JZ24-32 FELDMAN KIA PRO LOCATION

PLANNING REVIEW

Rezoning Request from NCC (Non-Center Commercial District) to B-3 (General Business) with Planned Rezoning Overlay (PRO)

Section	24	
Site Location	South of Grand River Avenue, East of Meadowbrook (Parcels 22-24-326-014, 22-24-326-024)	
Site School District	Novi Community School District	
Site Zoning	NCC Non-Center Commercial	
Adjoining Zoning	North	I-1 Light Industrial District
	East	NCC Non-Center Commercial
	West	OS-1 Office Service
	South	R-4 One Family Residential
Current Site Use	Vacant; formerly Glenda's Garden Center – plant nursery/landscaping	
Adjoining Uses	North	Delta Fuels, office/service providers, Religious Organization
	East	Office Buildings
	West	Vacant
	South	Single Family Residences
Site Size	5.25 Acres	
Plan Date	May 9, 2024

PRELIMINARY SITE PLAN

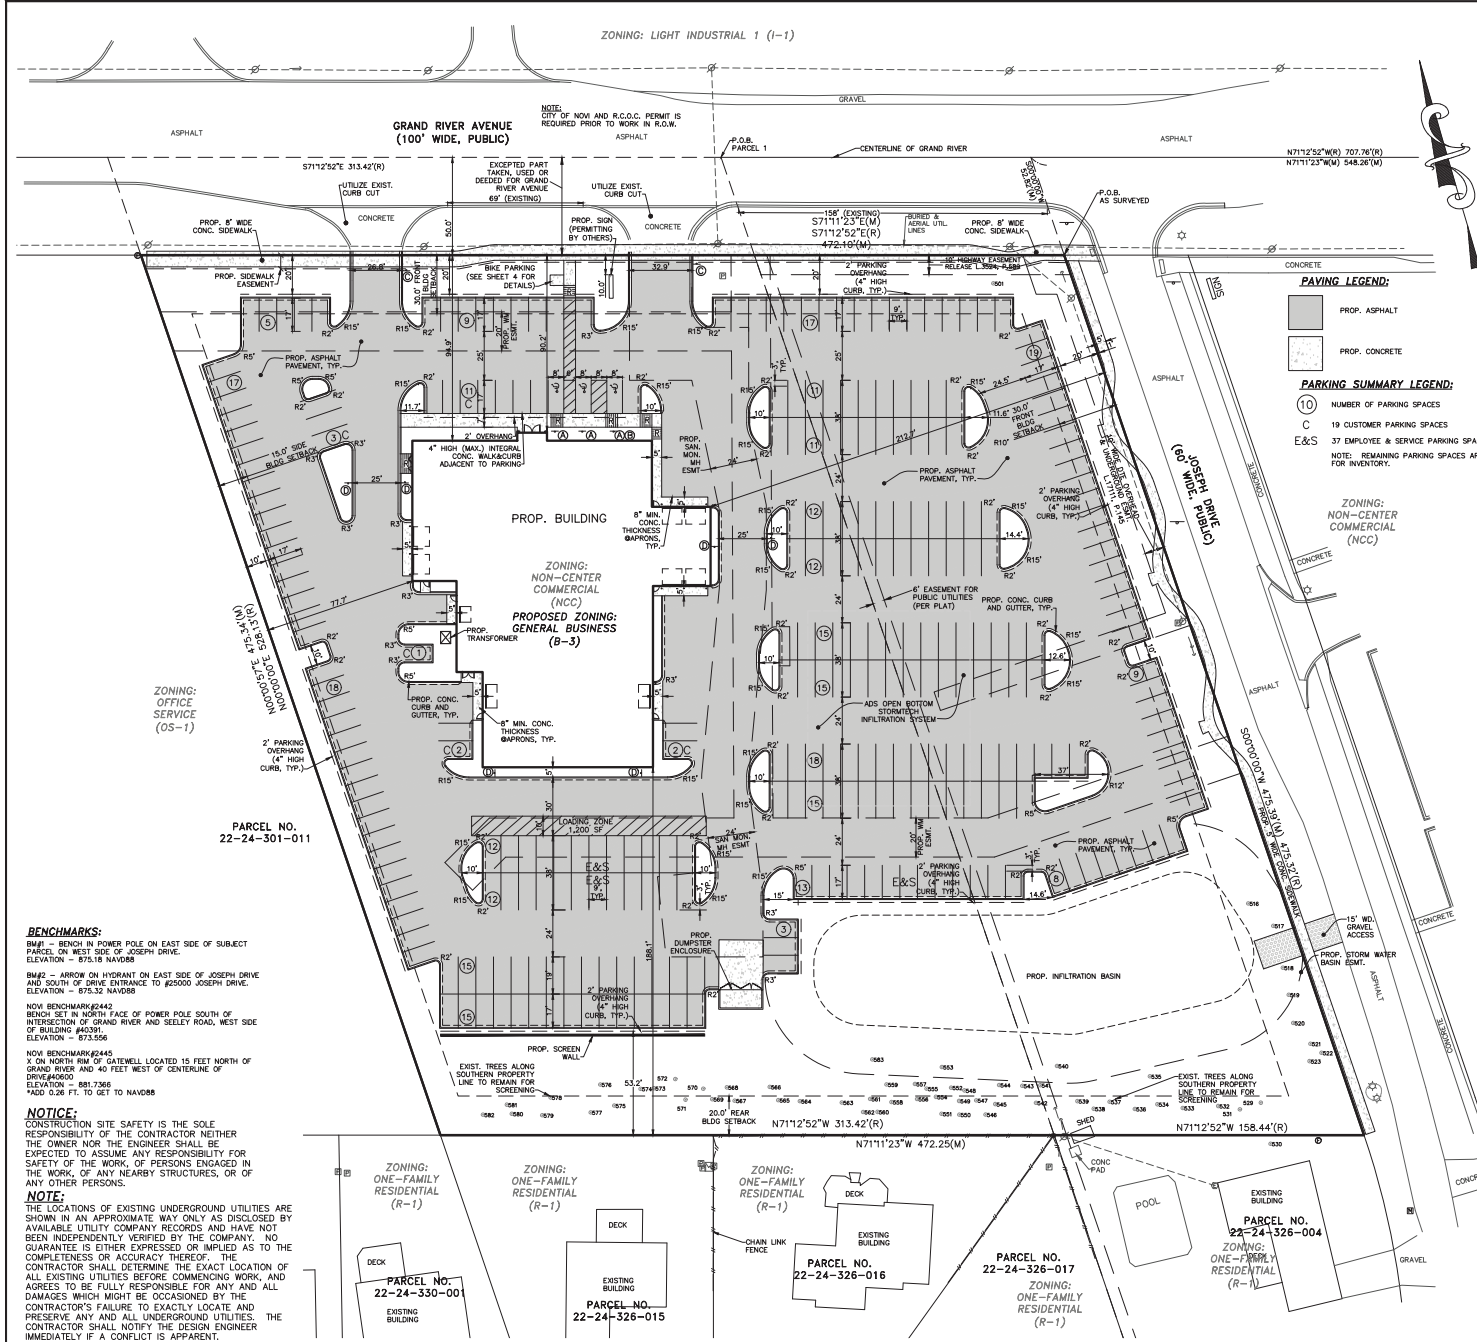
Staff Comment: As noted previously, there is conflicting information regarding the trees on the berm – Sheet 2 indicates they will "remain for screening" and sheets L-1 and L-2 state "Remove all trees as shown and leave all understory and shrubs." Staff is concerned that the proposed removal of existing trees (which are mostly in poor condition and covered in vines) without replanting on the berm does not offer a sufficient buffer to the adjacent residents to the south. If the trees are to be removed the height of the berm should be raised and new trees and/or fencing added on top of it to provide an adequate visual and aesthetic buffer to meet the ordinance requirements for 80% opacity in winter and 90% opacity in summer. This is particularly

Bench - 3 Total

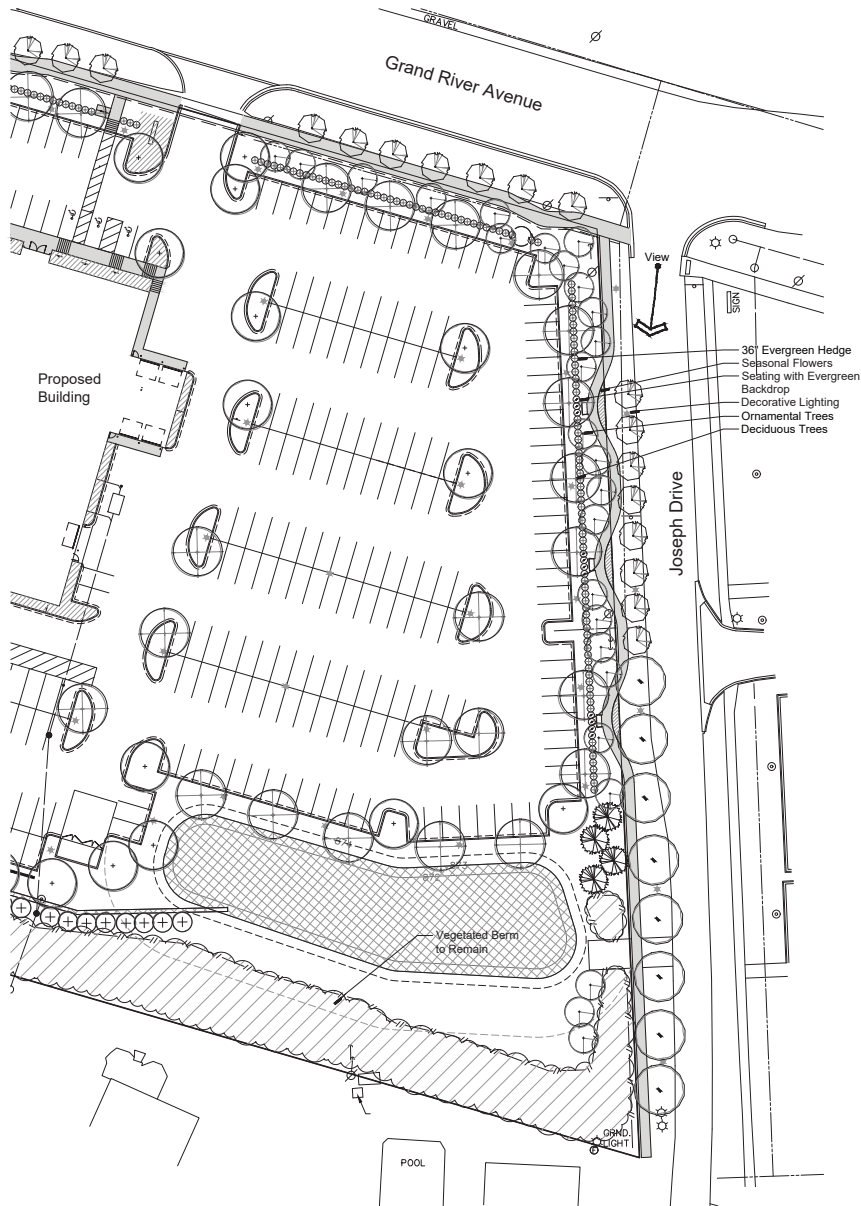
Staff Comment: Sheet L-4 of the PRO Plan shows a total of 3 benches to be provided at intervals along the sidewalk, and includes a detail of the proposed benches and decorative lighting fixtures. The benches and decorative lighting can be considered an enhancement. Providing a sidewalk on the Joseph Drive frontage is a requirement, so the meandering nature of it is the only unique feature, which may or not be considered an “enhancement.” As for the landscaping, the only element that exceeds what is required by the ordinance

SP1.1

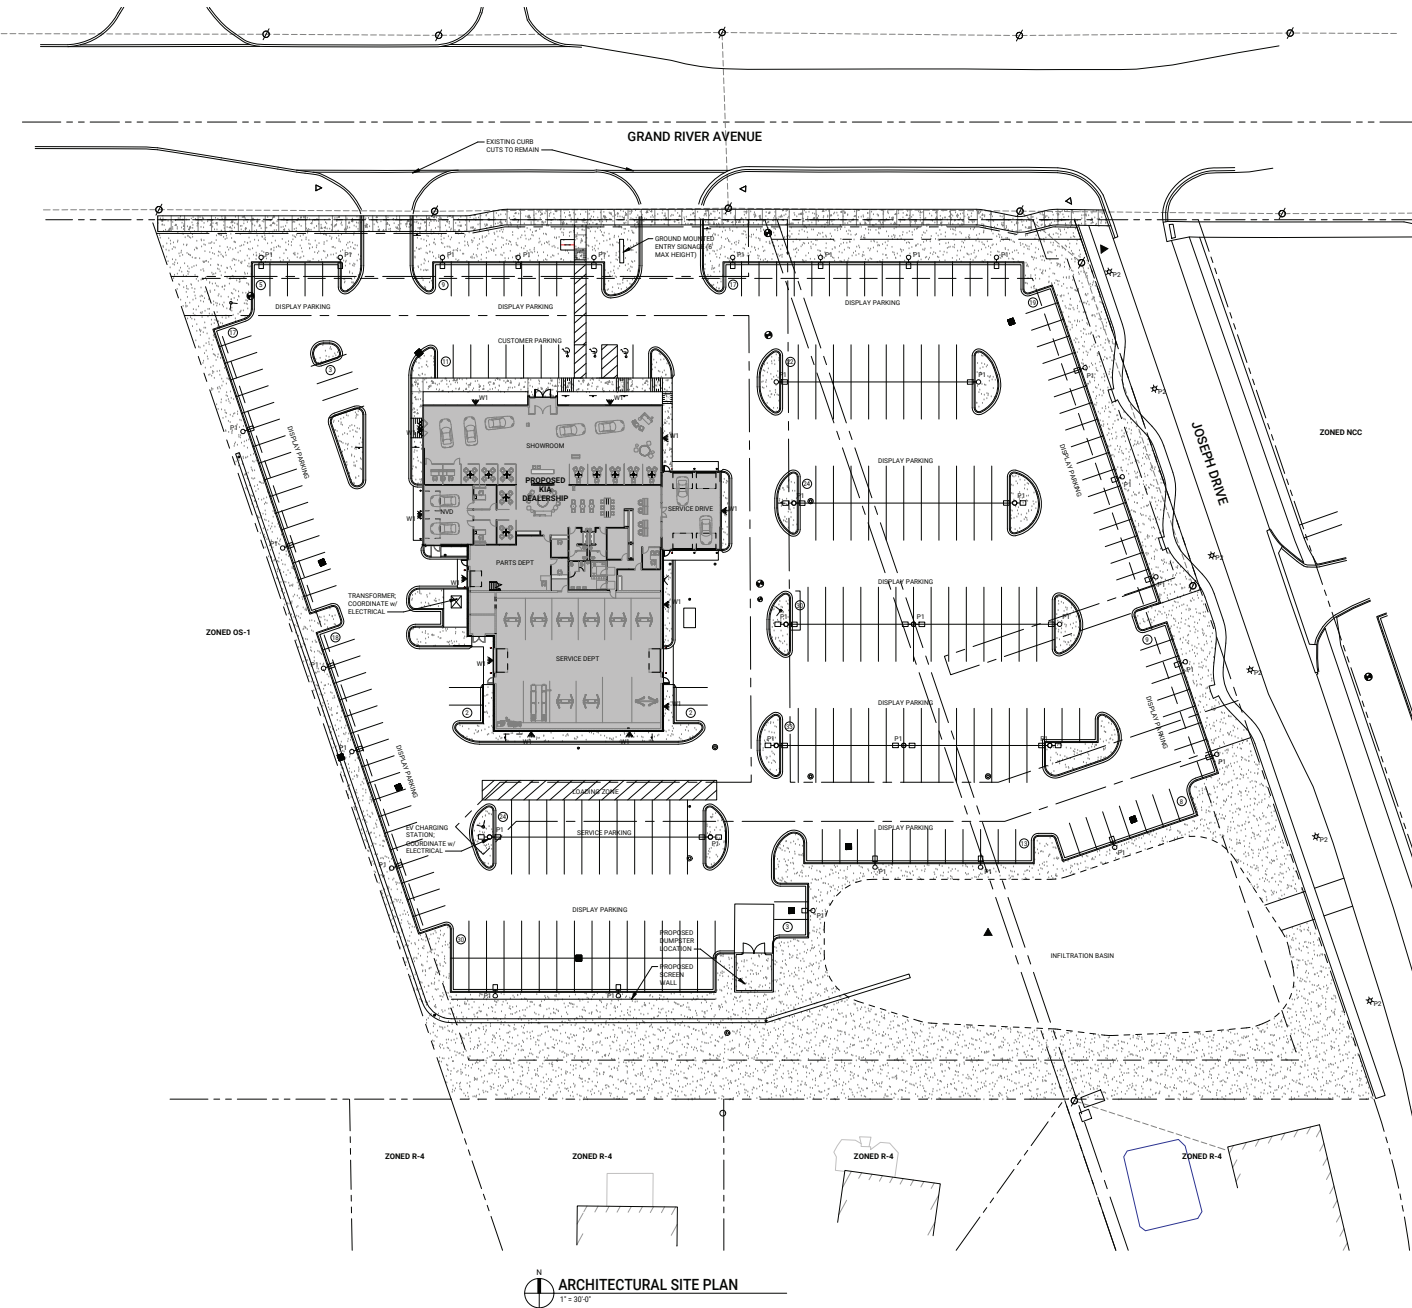
Response: Refer to the updated PRO narrative prepared by Landry, Mazzeo, Dembinski & Stevens PC.
- ***Comment: Dumpster Enclosure – Enclosure detail shown on sheet SP1.4 – enclosure should be brick to match the building. See Façade review.***

SP1.3

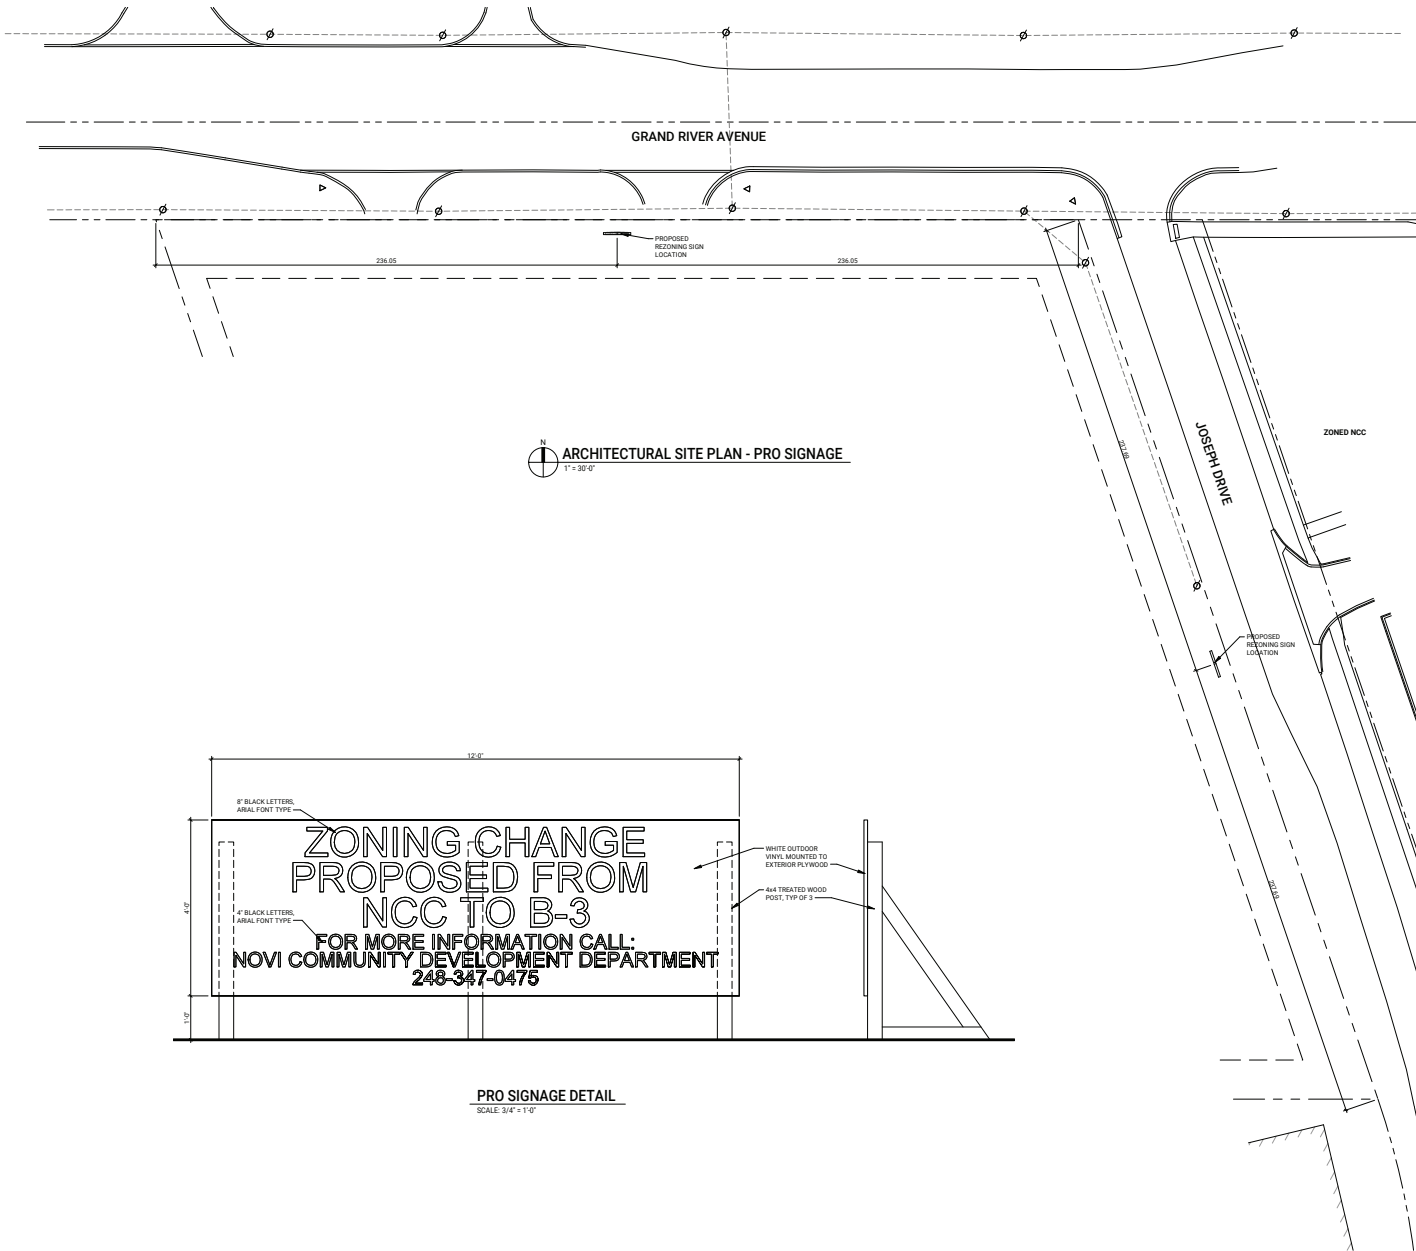
- d. Sign Location Plan: **A rezoning sign location plan and sign detail has been provided on Sheet SP1.3. The sign locations and wording are acceptable.**

A2.1

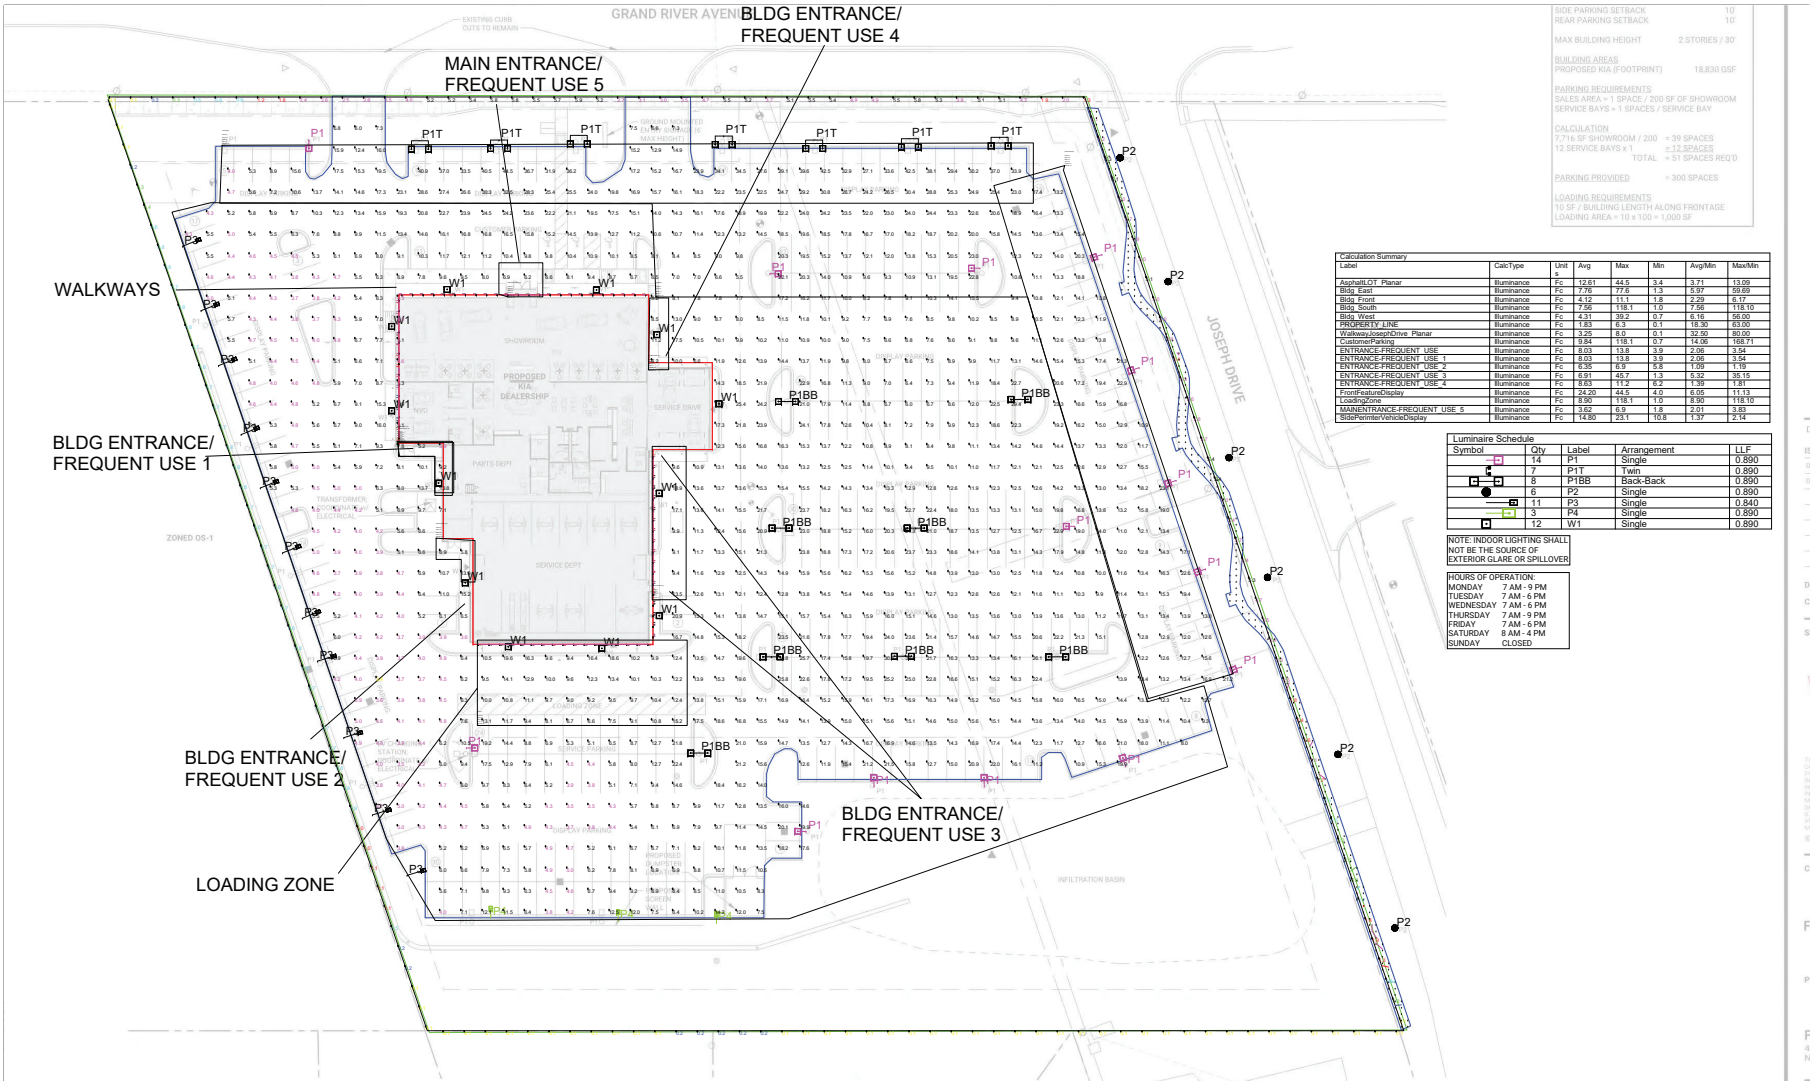
The applicant is proposing 3 wall signs on the north elevation, which is 144 feet from the Grand River centerline ("KIA" 13'x3' = 39 sf, "Feldman" 13'x2' = 26 sf, "Service" = 9'x1.5' = 13.5 sf) with a total area of 78.5 square feet. One sign is proposed on the east elevation ("KIA" 13'x3' = 39 sf). One ground mounted sign, located 60 feet from the street centerline, is shown as 5 feet tall with a total area of about 40 square feet. **The applicant should clarify if these estimated dimensions are correct and provide additional information to be able to evaluate the deviations from the requirements of the sign code: ground sign distance from the centerline of Grand River, and the total area of each sign proposed (box placed around the entire sign area as shown to the right). A Sign Permit Application will be required for each sign proposed.**
